FORM 9
CERTIFICATE OF SUBSTANTIAL PERFORMANCE OF THE
CONTRACT UNDER SECTION 32 OF THE ACT

C13-60-22: Tender for Rooftop Units (RTUs) Replacement at Fire Prevention Administration Building and Fire Station 4

Final Field Inspection Report

Report No.: M-01 Report Date: Nov 17, 23
Project: RTU Replacement- Inspection Date: Nov 06, 23
Fire Prevention Administration Building
55 King William Street, Hamilton, Ontario.
& RTU Replacement-Fire Station #4
729 Upper Sherman Avenue, Hamilton, Ontario.
Contract: C13-60-22
Our Project No.: BE22107031
Weather: 10 oC, Cloudy
Duration of visit: 9:00 am – 11 pm

Building: Fire Station # 4

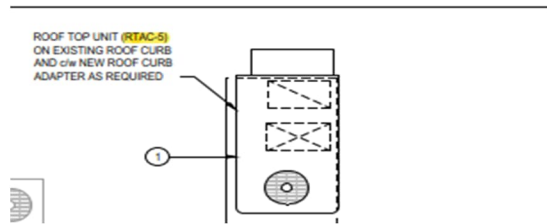
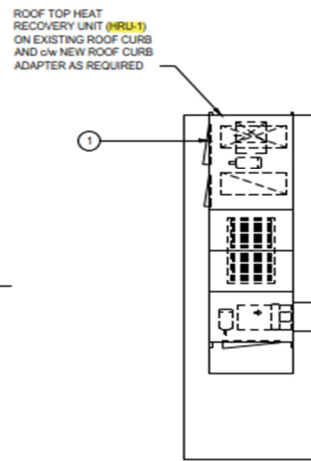
- HRU installation is not completed, connections are still pending.
- Need proper tags for the all the units based on the design drawings.
- Contractor has to provide the commissioning reports, O&M manuals for all the newly installed roof top units and VAV boxes.
- The roof top units and VAV boxes are not connected to BAS.
- Need duct leakage test reports.
- Need proper tags for the all the units based on the design drawings.

S.No.	Description	Status	WSP E&I Comments	Status / Comments from Contractor
1.	HRU installation is not completed, connections are still pending	Open Closed		Complete
2.	Need proper tags for the all the units based on the design drawings.	Open Closed		Complete
3.	Contractor has to provide the commissioning reports, O&M manuals for all the newly installed roof top units and VAV boxes.	Open Closed	As per the specification	Complete
4.	The roof top units and VAV boxes are not	Open Closed	As per the specification	Complete

connected to BAS. Contractor to provide BAS overview to the City when BAS integration is complete.			
5.	Need duct leakage test reports.	Open Closed	As per the specification. Provide justification if not provided.	Duct leakage tests have not been performed. All RTU's down discharge, duct work remains untouched. VAV's removed and replaced in existing locations and sealed on both connections.
6.	Provide 100mm (4") Roxul insulation on top of roof within entire curb structure for sound attenuation as required.	Open Closed	As per the specification. Please provide justification if its not provided	Complete
7.	The location of the VAV for room 110 is incorrectly shown in the drawings.	Open Closed	See the Observation for this item.	VAV was not in the location indicated on the drawings. New unit has been installed in the same location as the existing.

VAV-1 Manufacturer's tag

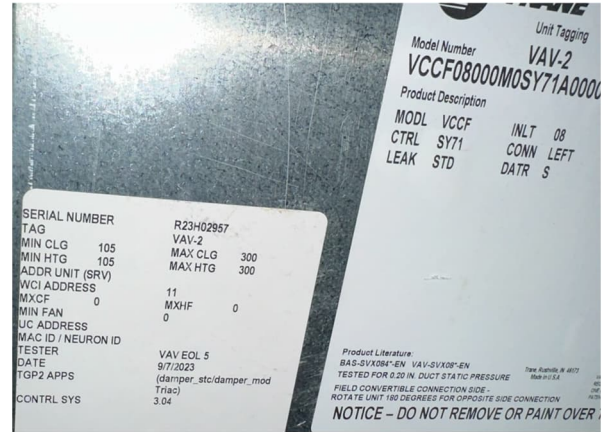
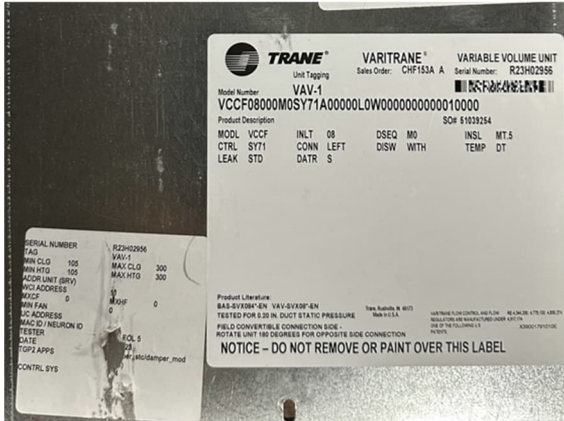
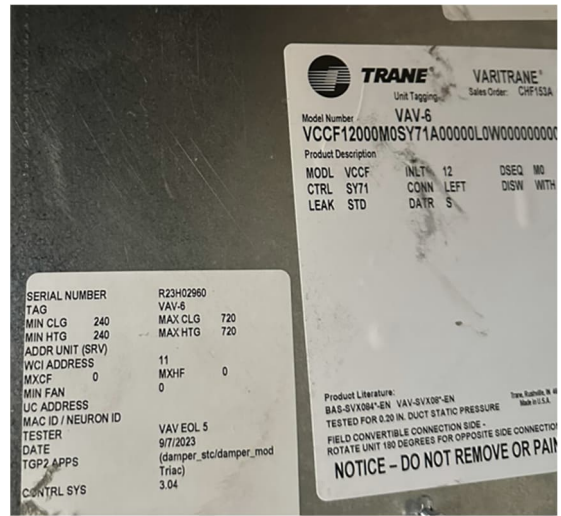
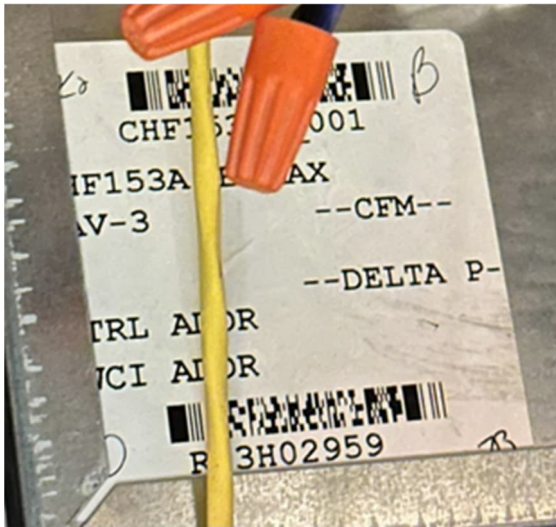
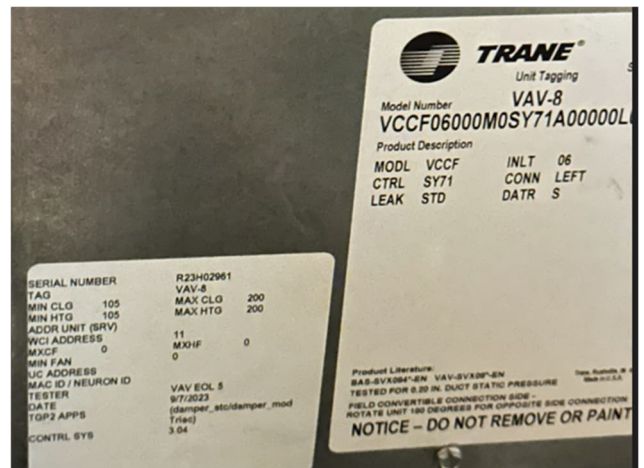
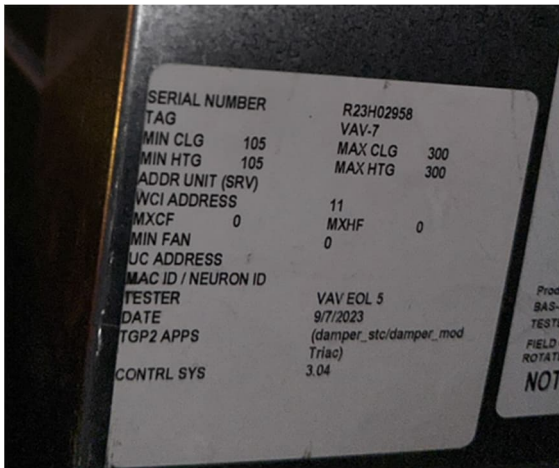
- The location of the VAV for room 110 is incorrectly shown in the drawings.

- All the VAV boxes should have completed installations with all connections, and the box covers should be tightened properly.
- VAV-3 and VAV-7 tags were not visible properly as the ceiling grids restrict reaching there.
